Board of County Commissioners Summary Report

Case name: **PM22-006**
Arcadia Creek

RE: Arcadia Creek – Variance Requests to the Private Access

Re: Revised Variance Request Arcadia Creek
Technical Review Committee

DETENTION VARIANCE EXHIBIT

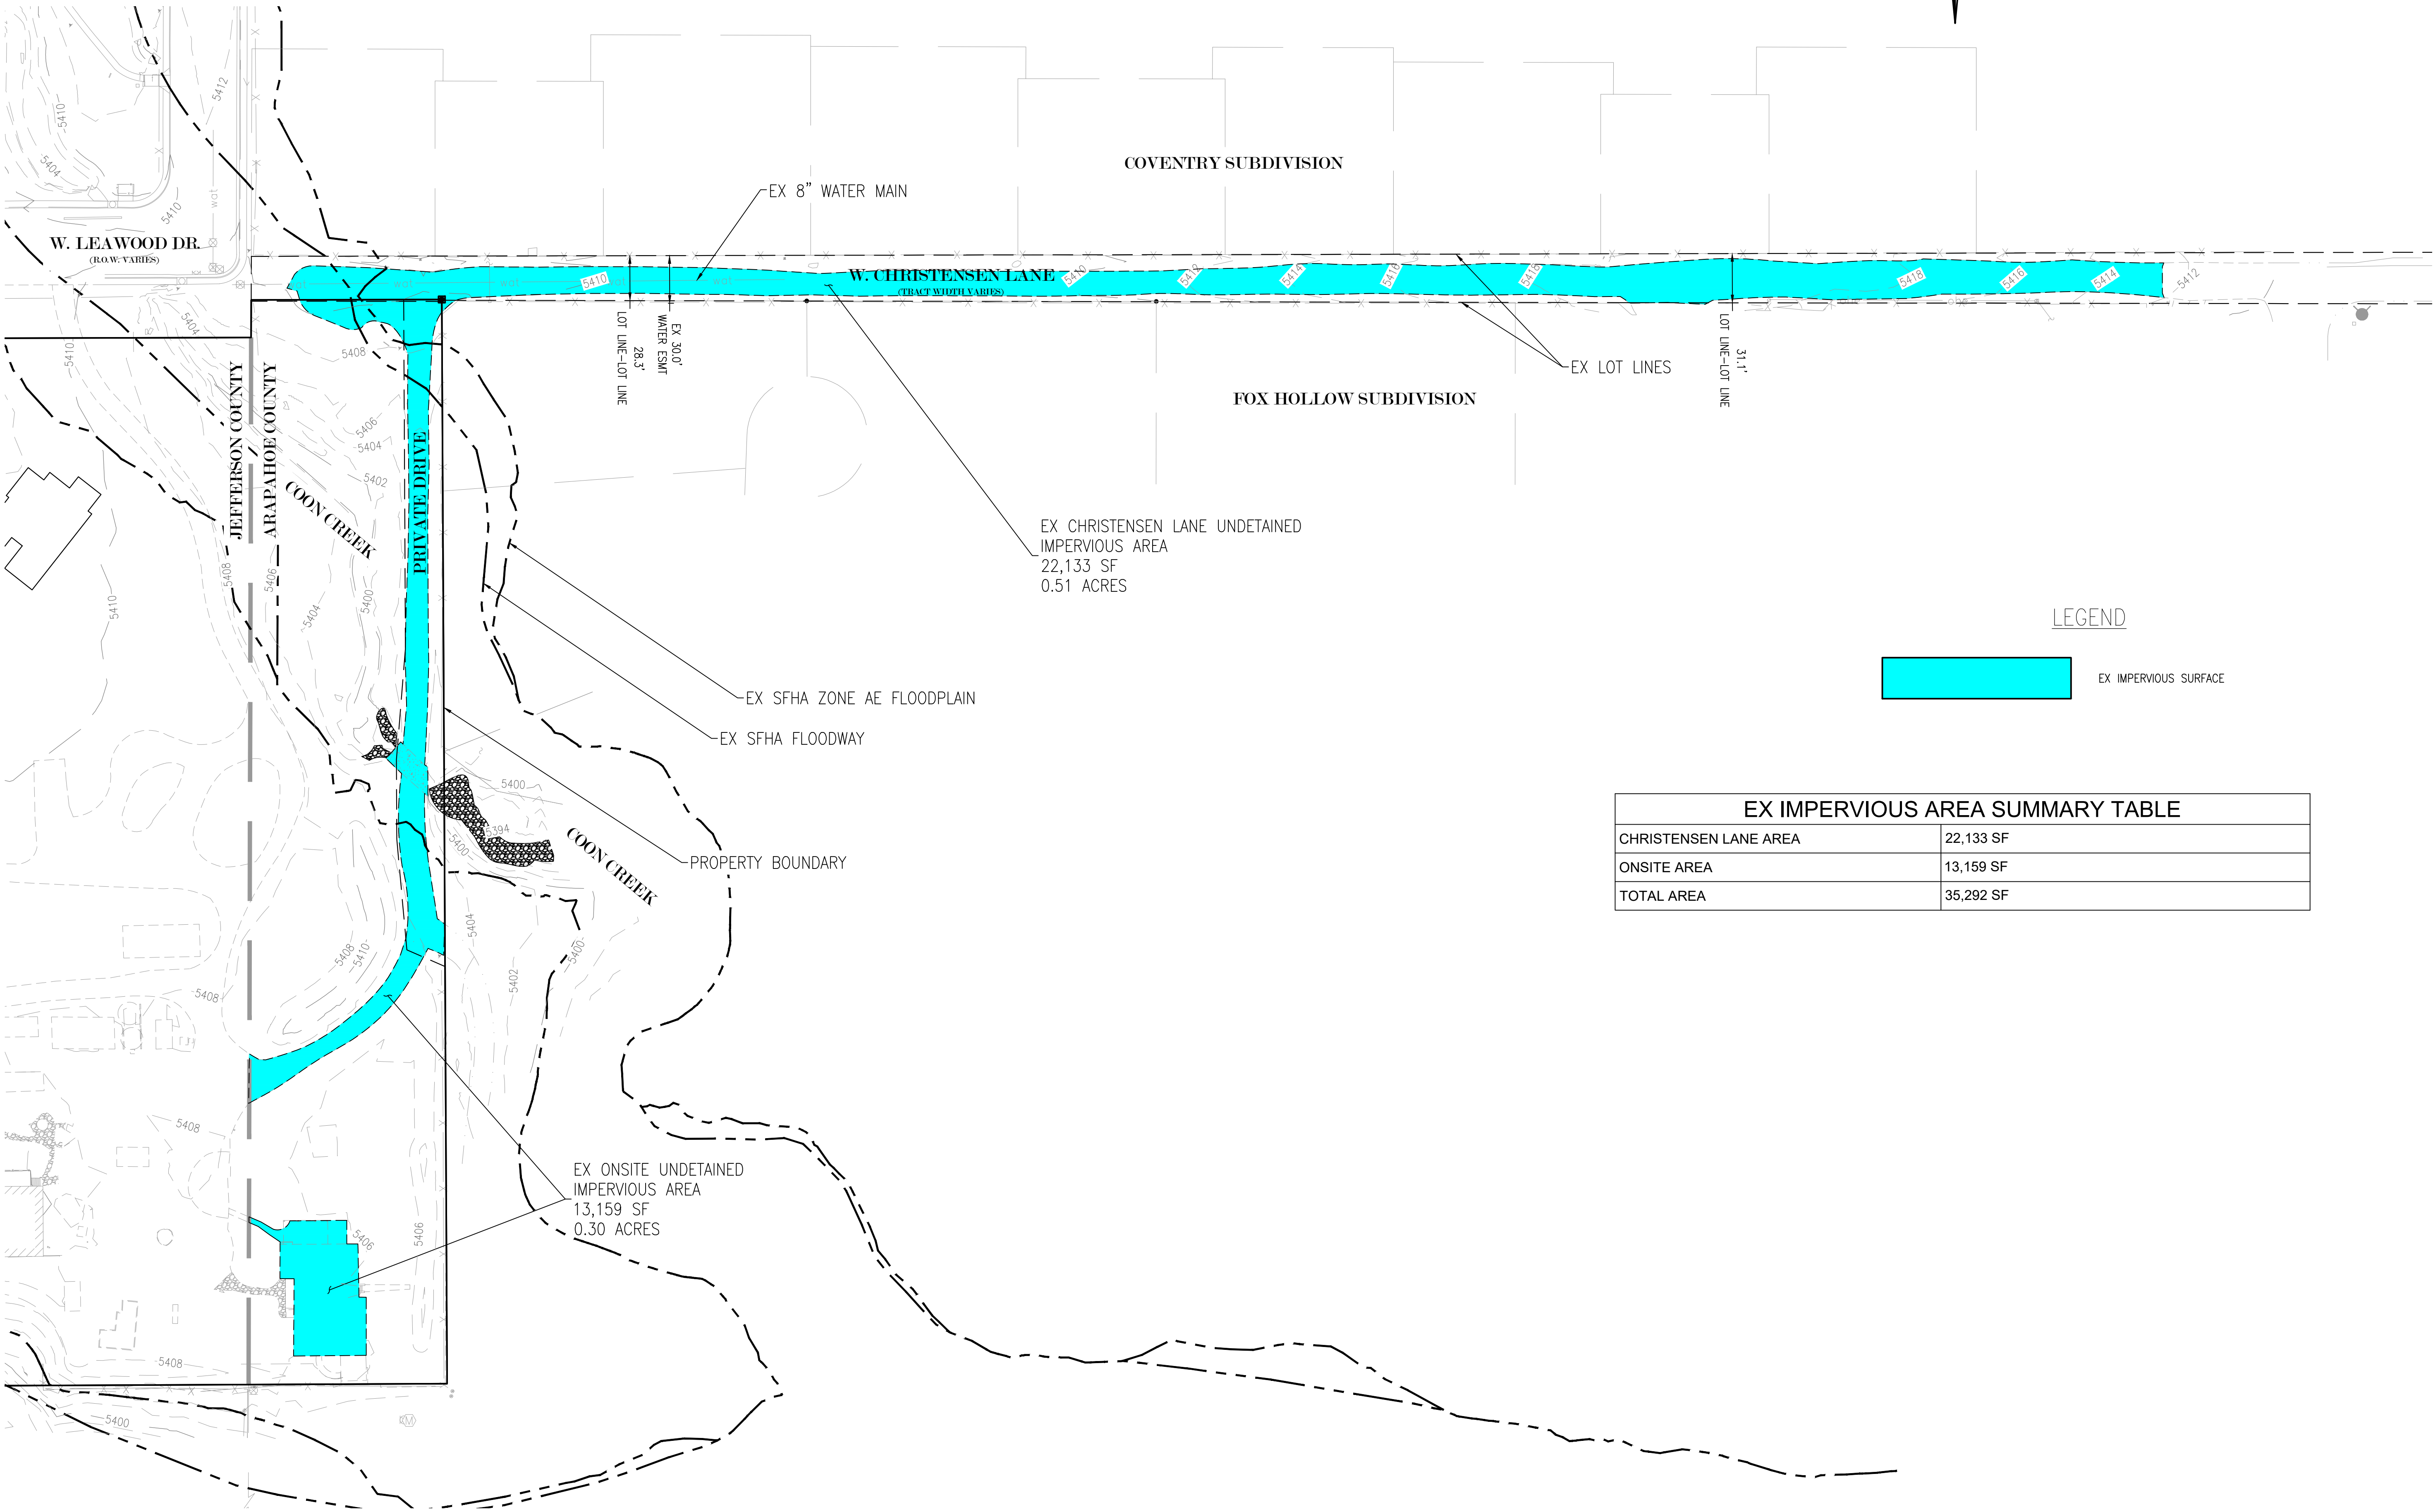
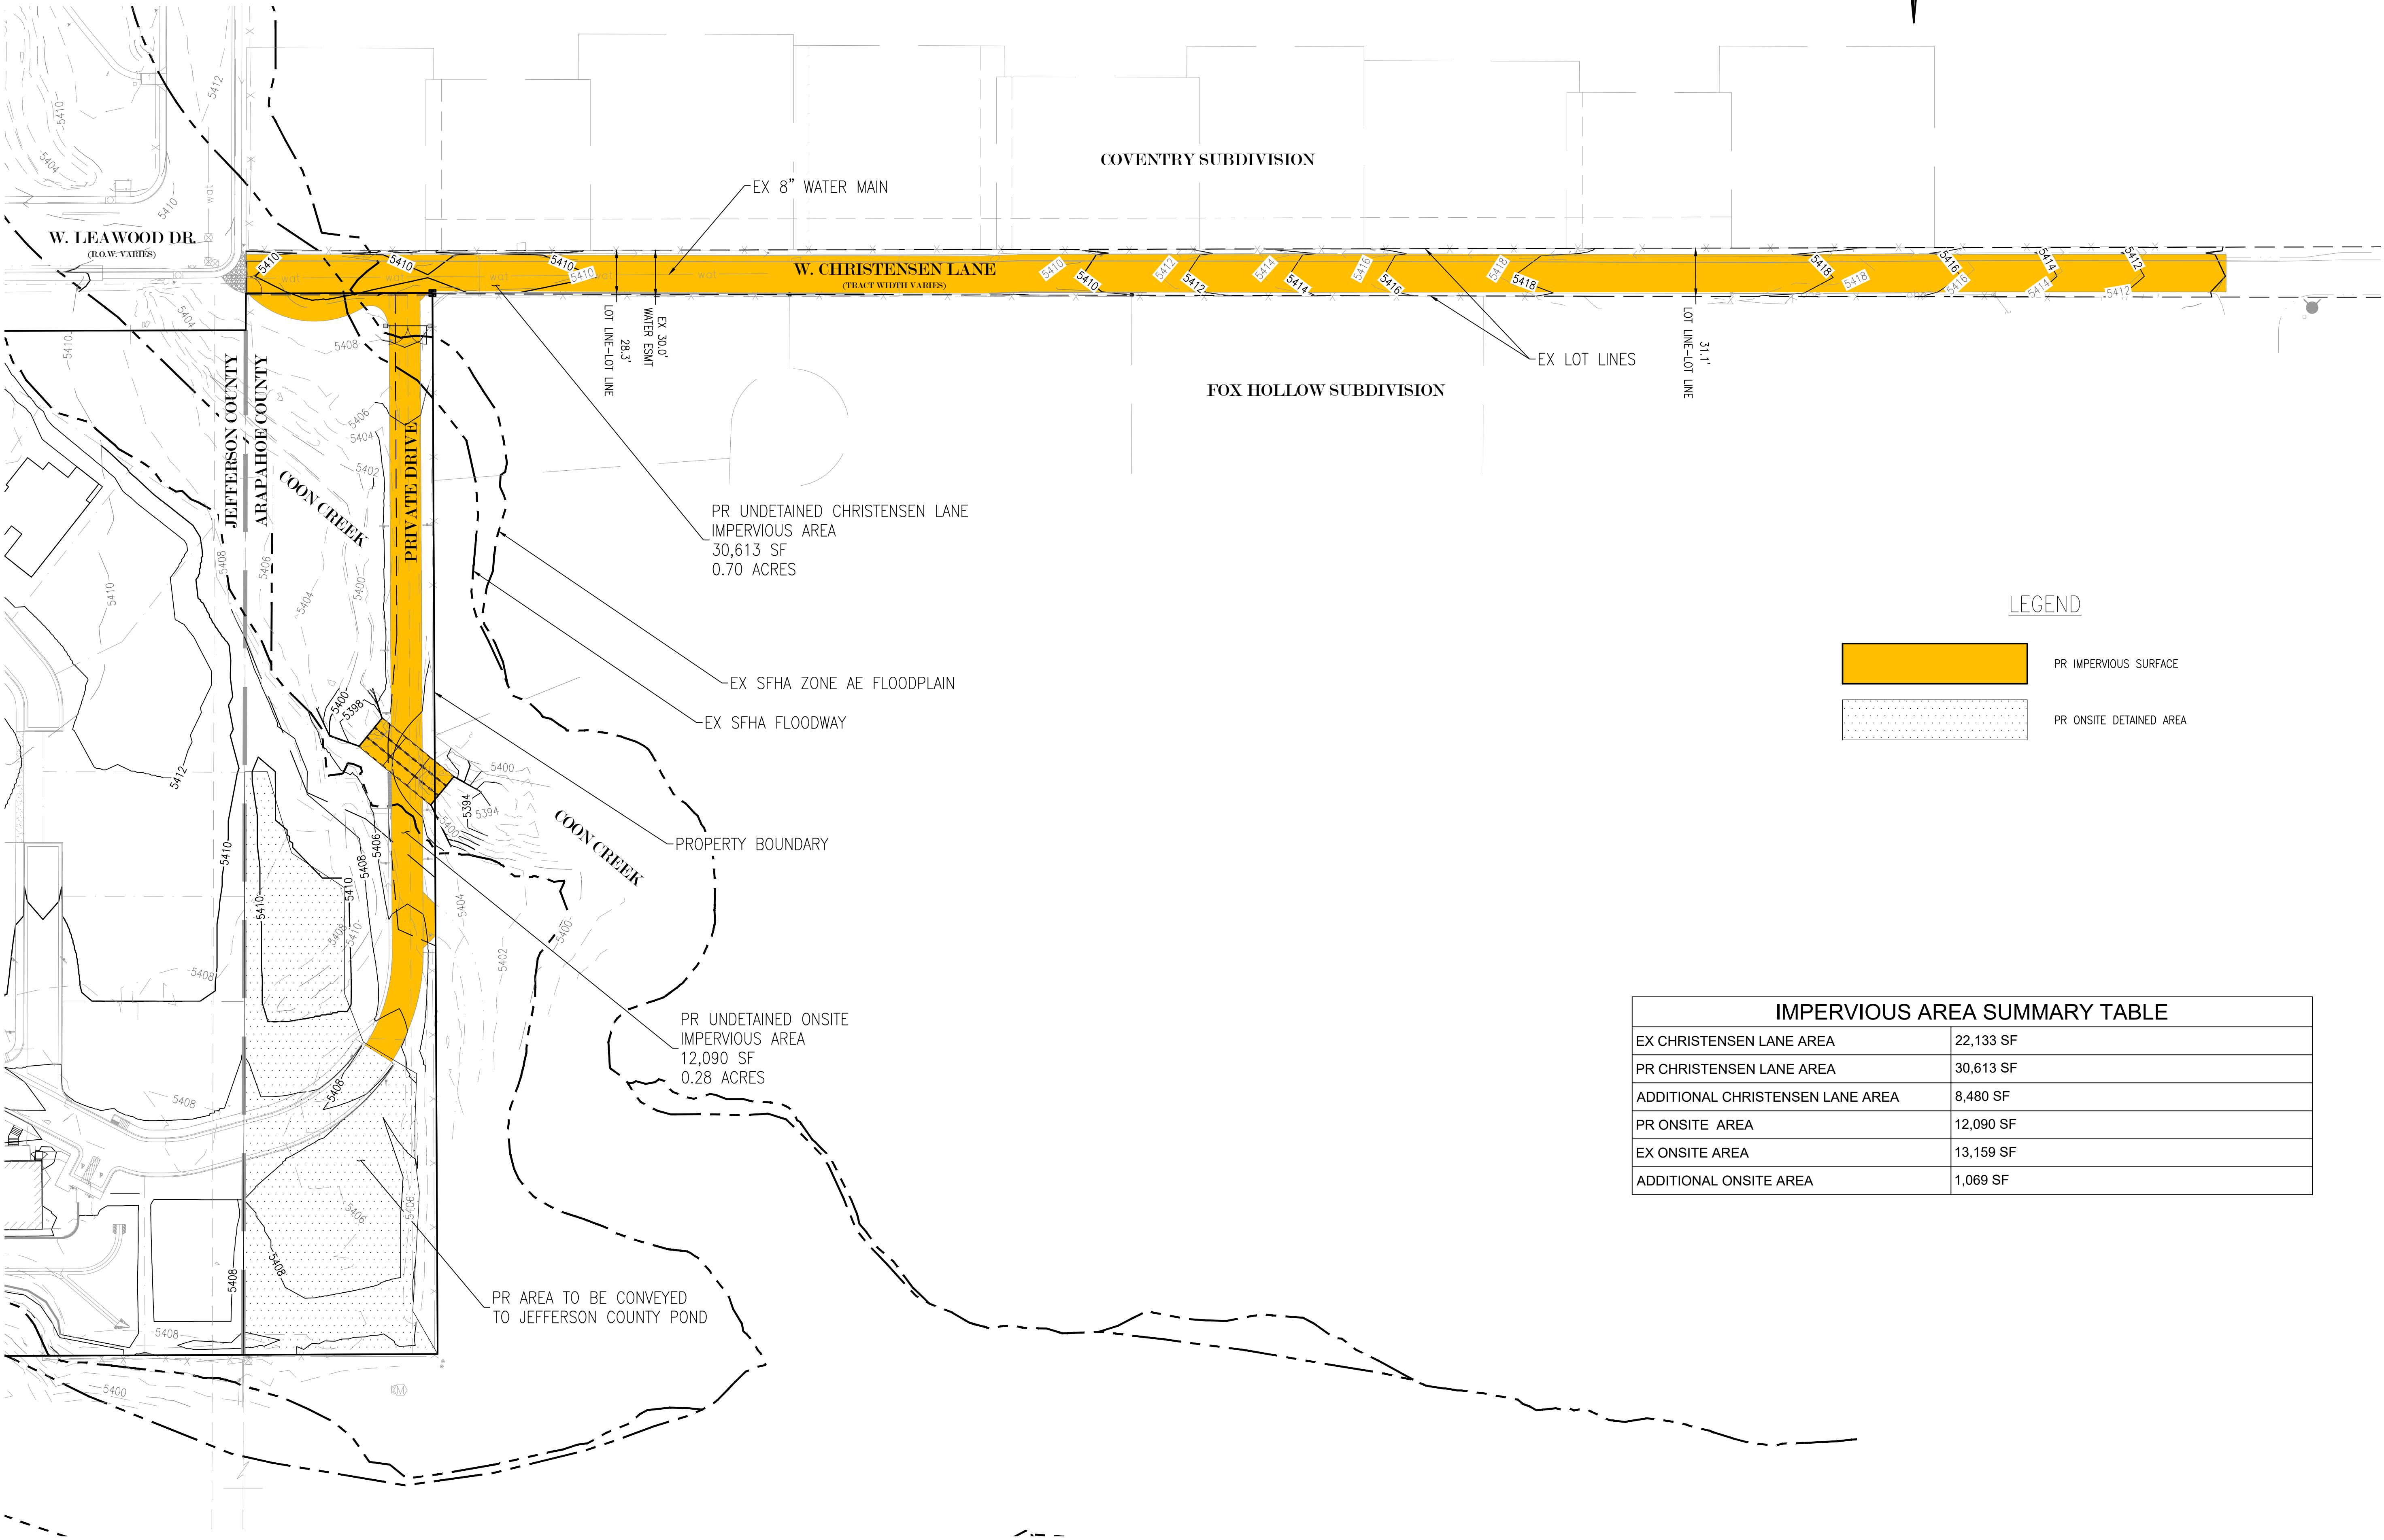
- Detention ponds must discharge at or above the 100-year base flood elevation of the adjacent tributaries. This requirement is to ensure proper hydraulic function of a detention pond when flooding of the tributary occurs. To meet these criteria, a proposed pond must have a minimum invert elevation (pond bottom) of 5409, as illustrated on Sheet 31 of the FHAD for Dutch Creek, Coon Creek, Lilley Gulch, and Three Lakes Tributary prepared by Mile High Flood District. If enough area were provided onsite to construct a pond, existing topography would prevent the required elevations from being met. Topography would not allow the capture and transport of runoff from the lane into a detention pond at the required invert elevation.

The applicant shall provide detention per Section 13.1 .1 of the Arapahoe SMM to the extent physically possible. These areas include the two single family dwellings and associated private drive, the southern portion of the subject property. See attached exhibit for clarification.

The applicant shall remove and replace existing inlets along Christensen Lane, supporting a more robust drainage conveyance system. The existing storm sewer within Christensen Lane shall be cleaned of debris to help facilitate the transport of runoff to Coon Creek. The existing outlet into Coon Creek shall be repaired and sediment removed. The outlet pipe shall be retrofitted with updated erosion control measures including rip rap and energy dissipation.

- Existing and proposed flow rates and change in flow rates.
- Discuss how the un-detained flows will impact Coon Creek and Dutch Creek.
- Discuss how this flow impacts the peak within Coon Creek.
- How much detention volume would be required to detain the flows.
- Was any offset provided with the ponds in Jefferson County for the flows that go to Coon Creek? For example, did any flows that went to Coon Creek get transferred to Dutch Creek and included in the pond volumes?
